TYPICAL SECTIONS FIELD CHANGE No. 3

Sketch No. 15 To Accompany Field Change No. 3 IH45 Project 145-1650011 Control 500-4-56 Galveston County

Typical Section Sect

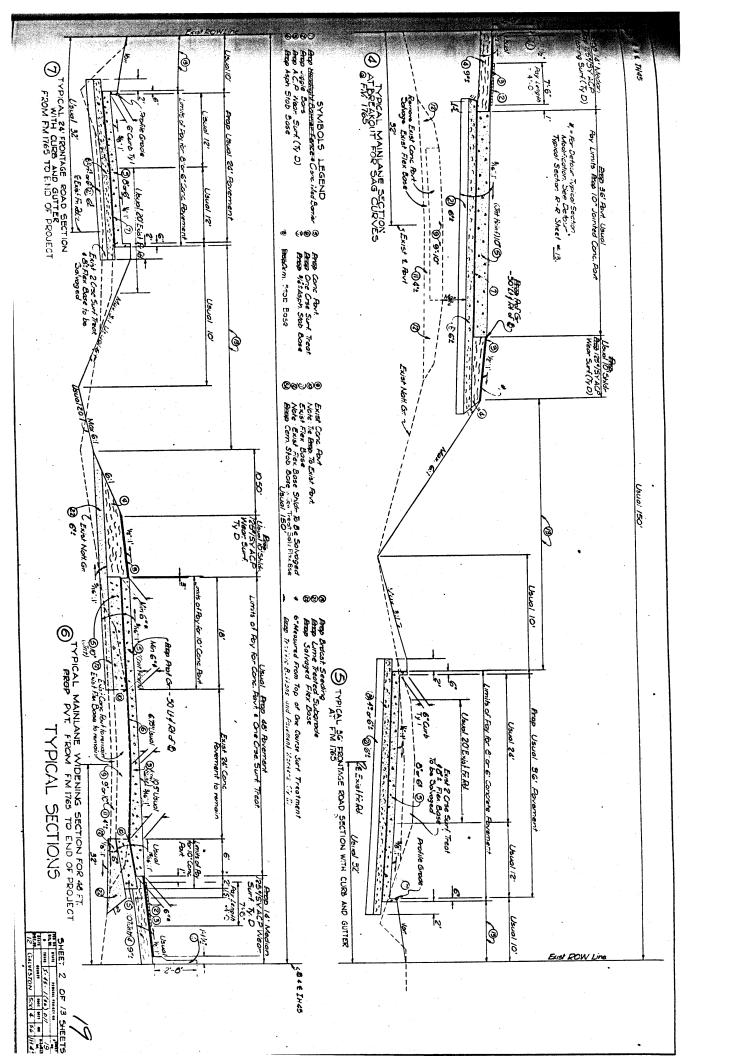
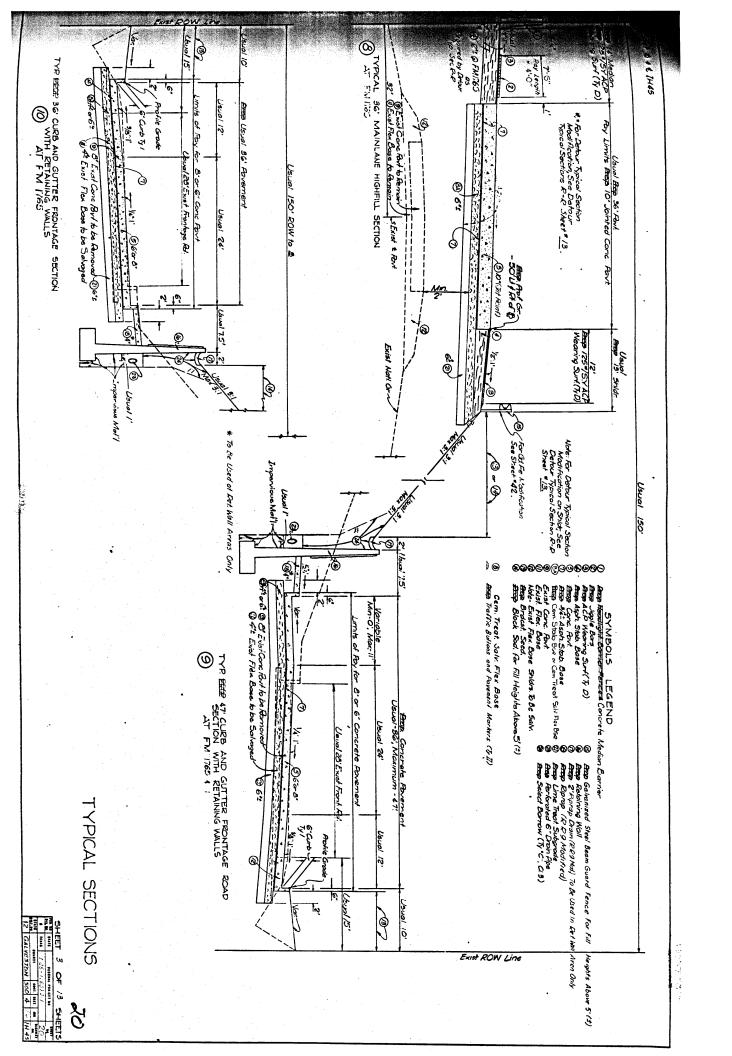
Modify Median Slops, Asch. Stat. Base Dopth and Asch. Conc. Rvt. of Typical Section No. 3 Median between the following Stations:

\* Remove portion of detour ACP liear Surf.(Ty Hor L) as required to maintain a minimum depth of it for the final median surface ACP liear Surf.(Ty D). Removal of defour ACP as required shall be considered incidental to various bid llems.

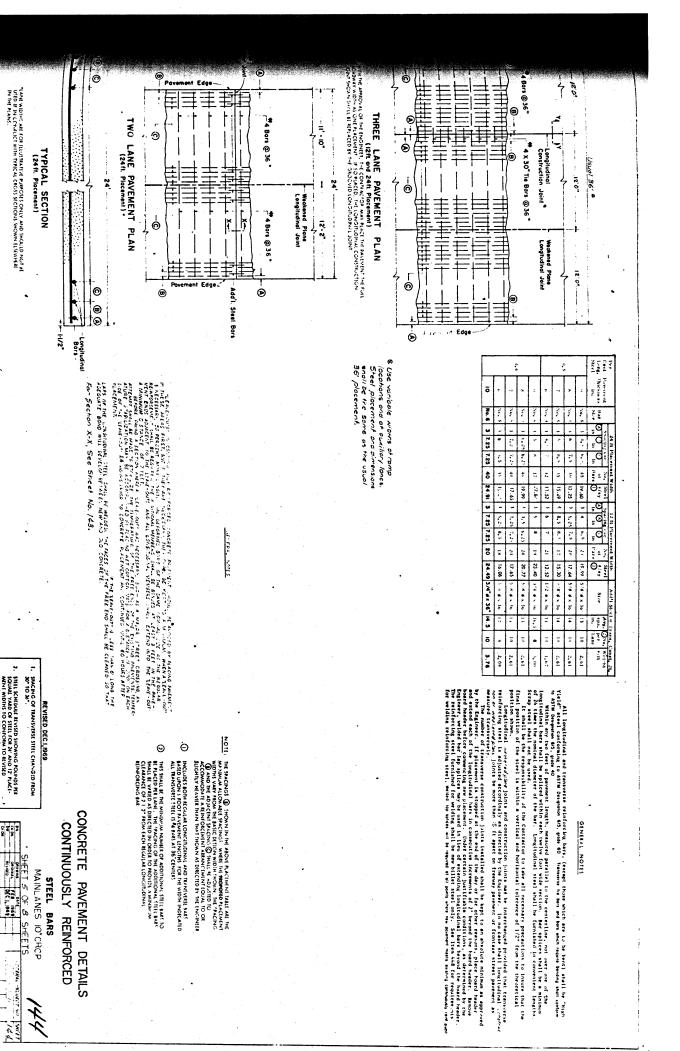
3. STEEL SCHEDULE REVISED SHOWING POUNDS PER SQUARE YARD OF STEEL FOR 24' AND 12' PLACE-MENT WIDTHS TO CONFIDM TO REVISED TRANSVERSE STEEL SPACING.
